Florida Department of Environmental Protection

RE: WARNING LETTER OF POSSIBLE VIOLATIONS AND NON-COMPLIANCE

**Miami Harbor Phase III Federal Channel Expansion
Permit No. 0305721-001-BI
County: Miami-Dade**

**Field notes on impact assessment in Miami Harbor Phase III Federal Channel
Expansion Permit # 0305721-001-BI**

Figure 33. *Porites astreoides* colony experienced considerable burial and partial mortality (see also next picture).

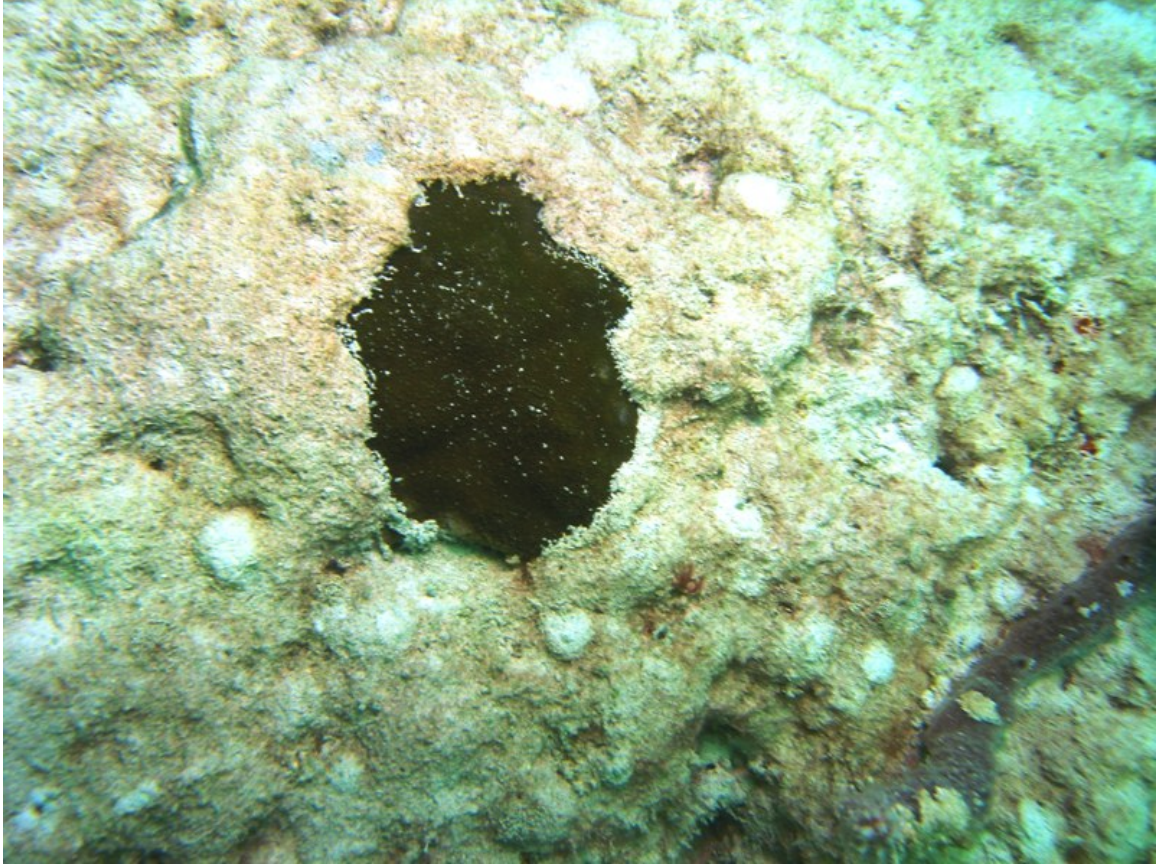
buried or almost buried; the mortality in larger scleractinians was observed at the edges of colonies, which are buried under sediments that have been shed down from the top of the colony (Figures 30, 33, 34). The zoanthid *Palythoa caribaeorum* is sediment tolerant, but colonies at this site were overloaded with sediments and may not survive (Figure 29). Sediments appeared to have been deposited recently, and cyanobacterial mats had not formed as an extensive cover as at sites on the southern side of the channel in the area of the Inner Reef. At the end of the transect, i.e. in a distance about 180-200m from the monitoring station, small groups of *Acropora cervicornis* were recorded growing west of the transect and at the end of transect (Figure 35).
